Diamond View Estates 2024; KPB File 2024-040
 Geovera, LLC / Sookraj
 Location: Diamond Ridge Road & Volcano View Court
 Diamond Ridge Area / Kachemak Bay APC

ITEM #1 - PRELIMINARY PLAT Diamond View Estates 2024

KPB File No.	2024-040
Plat Committee Meeting:	May 13, 2024
Applicant / Owner:	Jerome Sookraj of Homer, Alaska
Surveyor:	Stephen C. Smith – Geovera, LLC
General Location:	Diamond Ridge Road, Homer Area

STAFF REPORT

DIAMOND VIEW ESTATES 2024

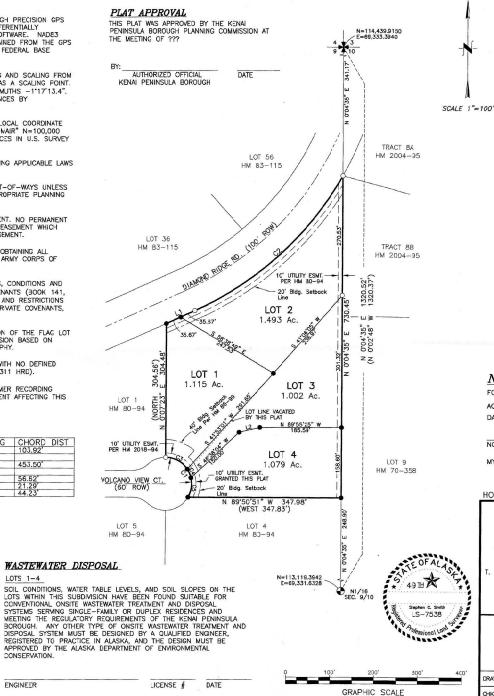
Volcano View Ct. will remain unaffected by this plat action except to make the cul-de-sac. RSA review shows concern that this is a driveway dense cul-de-sac and that an access permit for Lot 2 to Diamond Ridge Rd will be needed.

The 10' utility easement granted per HM 2018-49 to be labeled on plat along border with Diamond Ridge Rd. The 10' utility easement identified along Volcano View Ct. to be labeled correctly as HM 2018-49 on Lot 1 and per this plat on Lots 3 & 4. Draw and label the 10' x 10' HEA Easement per HM 86-99 on the north line near Diamond Ridge Rd also.

HEA	Provide a label for the 10' utility easement granted per HM 2018-49, Correct the reference to plat number 2018-49.
ENSTAR	
ACS	
GCI

Add the KPB file 2024-040 to the title block

There is an existing trail shown on the asbuilt included in the certificate to plat and visible on the aerial photo, this should be added to the drawing and labeled.

J. Block and lot numbering per KPB 20.60.140, approximate dimensions and total numbers of proposed lots; **Staff recommendation:** Lot 3 is within a previous recent Lot 3. Lot 2 similar issue. Consider 3A & 2C possibly

Diamond Ridge property access permitted through AK DOT. Application for driveway access from Lot 2 to state ROW will need to be approved.

Add to the drawing the 10' x 10' utility on the north line against Diamond Ridge Drive as created by HM86-99

Add map panel info

10' utility easement granted per HM 2018-49 to be labeled on plat along border with Diamond Ridge Rd. 10' utility easement identified along Volcano View Ct. to be labeled correctly as HM 2018-49 on Lot 1 and specify that on Lots 3 & 4 for this plat.

- "No access to state-maintained rights-of-way permitted unless approved by the State of Alaska Department of Transportation."
 - Add a plat note referencing plat note #4 HM 86-99 to the plat

Staff recommendation: comply with 20.60.190. Add the date of May 13, 2024 to the Plat Approval
